Service Manual

KX-TG1233JXS KX-TG1233JXT KX-TCA122CXS KX-TCA122CXT KX-TCA121CXS KX-TCA121CXT

Digital Cordless Answering System

Please file and use this supplement manual together with the service manual mentioned below.

SCHEMATIC DIAGRAM (BASE UNIT_MAIN) 2.5.

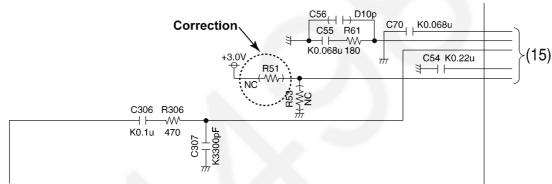
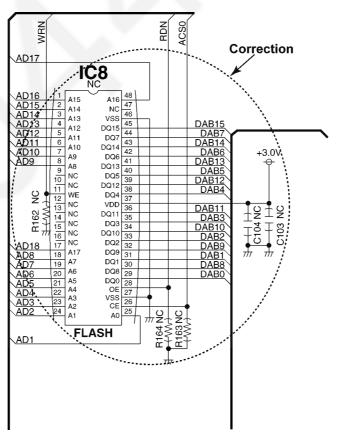
<u>in Cl</u>	<u>IRCUIT BOARI</u>	D (BASE UNIT MAIN) (P.85)	Addition
Ref.	Part No.	Part Name & Description	Remarks
PCB1	PQWP11233JXH	MAIN P.C.BOARD ASS'Y (RTL)	
		(ICs)	
IC1	C0DBZGE00007	IC	
IC3	PQWID300NEHR	IC (EEPROM) (*1)	
IC4	C1CB00002180	IC (BBIC) (*1) (*2)	
IC6	PQWI21233JXH	IC (FLASH MEMORY) Add	ition
IC7	C1BB00000265	IC	
IC8	PQWI31233JXH	IC (FLASH MEMORY)

HANGES CIRCUIT BOARD

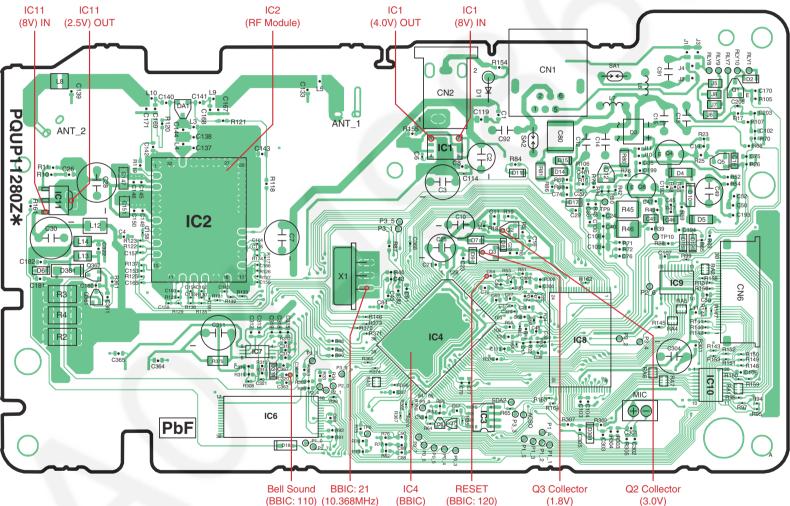
Note: (*1) Regarding IC4, only the new part "C1CB00002180" can be supplied even if the unit is the Old Type as in the Comparative Table. In this case, when replacing IC4, (1) order and install CICB00002180, then (2) remove IC8 and all the related resistors listed.

Comparative Table

IC4 (BBIC)

IC8 (FLASH)

Old Type

CICB00001879 (*1)

Related Resistors R51, R162, R163, R164, R371, R372, R373, C103, C104

New Type

C1CB00002180
